STAFF REPORT ACTION REQUIRED

5 Highland Avenue, Demolition and Replacement of a Structure within the North Rosedale Heritage Conservation District

Date:	February 9, 2009
To:	Toronto Preservation Board Toronto and East York Community Council
From:	Director, Policy and Research, City Planning Division
Wards:	Toronto Centre – Rosedale - Ward 27
Reference Number:

Surveyor's Real Property Report
PART 1 : Plan of
PART OF LOTS 12 and 13
REGISTERED PLAN 342-E
CITY OF TORONTO

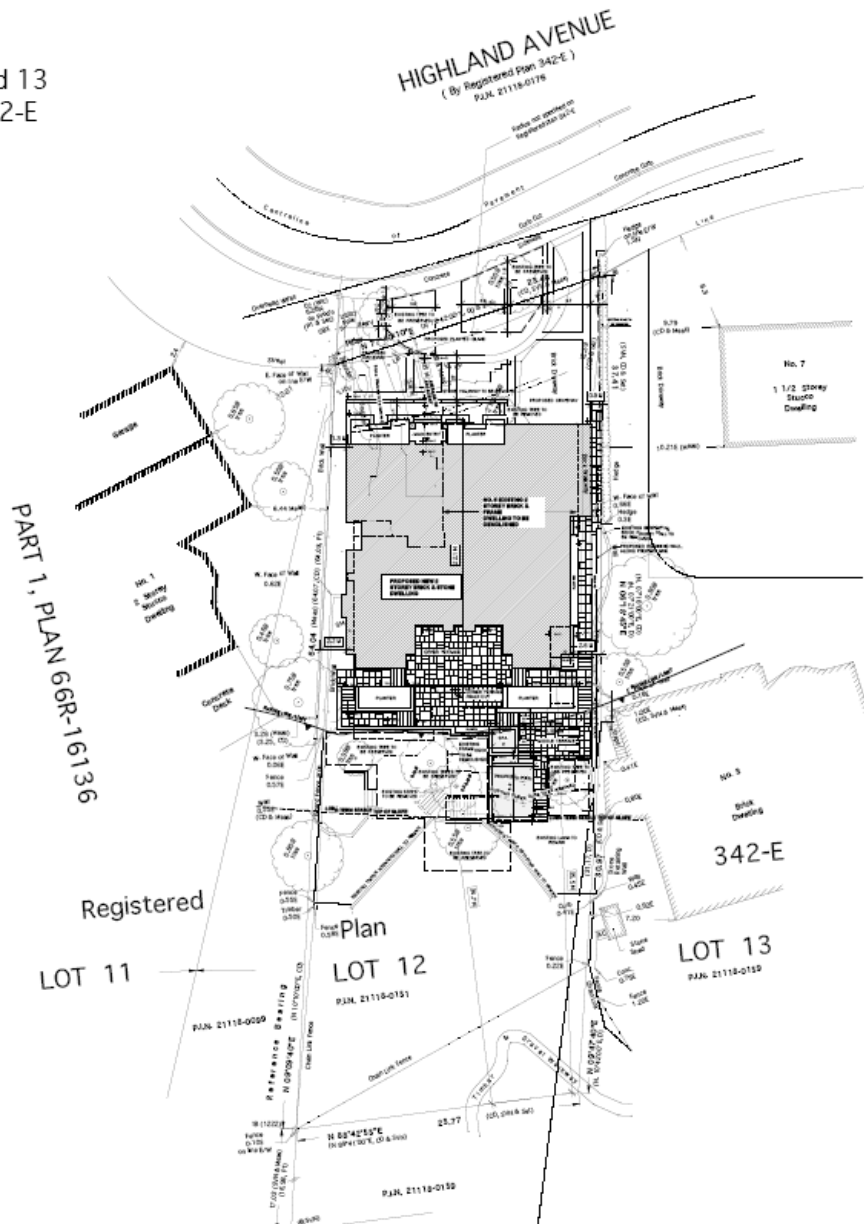
The proposal for a U-shaped driveway is not consistent with the zoning and results in too much paving in the front yard (Attachment No. 6). The NRHCD guidelines encourage the preservation of existing landscapes, trees and mature vegetation and note the characteristic large canopy trees in this area.

The U-shaped driveway should be replaced with a driveway that is single lane at the curb widening to two spaces at the front of the garage. A revised landscape plan would further mitigate the visual impact of the reduced setback of the replacement structure from the street. Care should be taken to protect the two City trees at the front of the property (Norway Maples).

Front Elevation

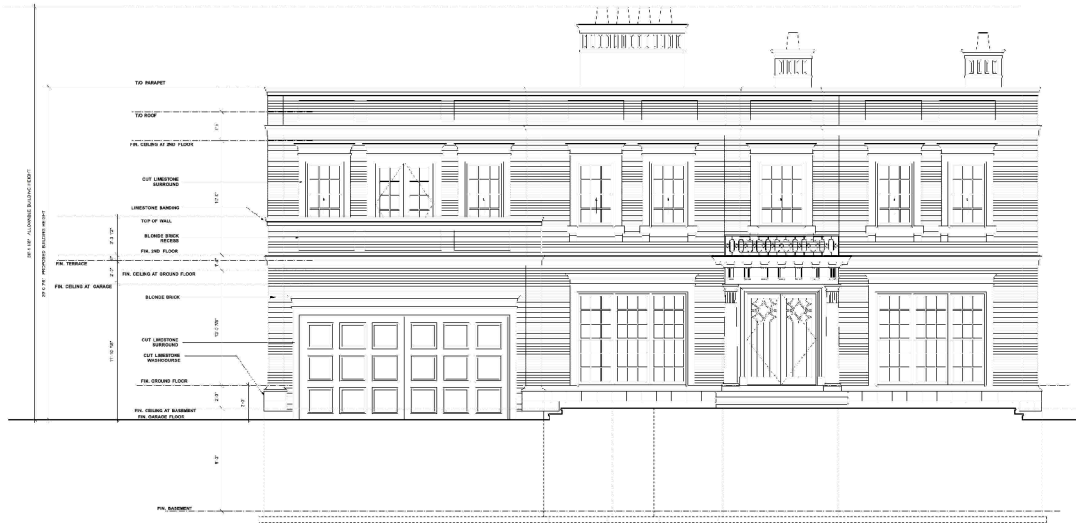
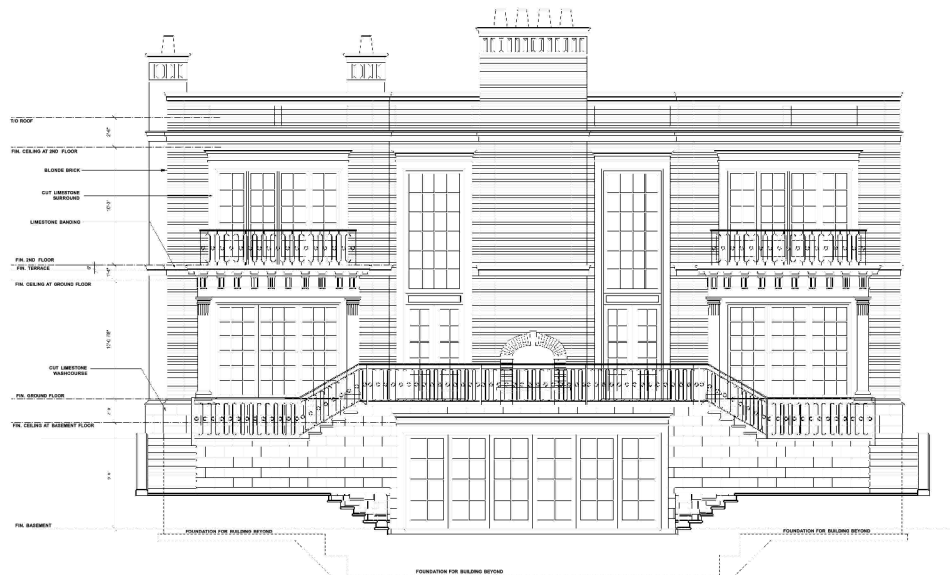
The design of the proposed house is a two storey classically inspired centre hall plan (Attachment No. 8). There are many examples of centre hall plan English Revival style homes in the district. However in this proposal the classic proportions are thrown off by the integral double garage which is set forward from the main face of the house, making the overall facade appear to be too long.

Integral garages and below grade entrances are strongly discouraged in the district however, in this instance the ravine lot makes it impossible to have a rear garage. Therefore staff are recommending that the appearance of the integral garage be mitigated by setting the front face of the garage back from the façade of the house.

HPS staff recommends that the design of the replacement building should be revised in order to comply with the guidelines for new buildings and enhance the heritage character of the district. The integral garage should be set back from the front façade in order to improve the character of both the house and streetscape. The appearance of the lengthy massing would be reduced and the symmetry of the façade enhanced by setting back the front of the garage. If the house plan cannot be moved any further back towards the ravine to accommodate this change then the interior layout would have to be altered. The large detailed chimney on the roof closest to the street should be reduced in size to minimize its visual impact.
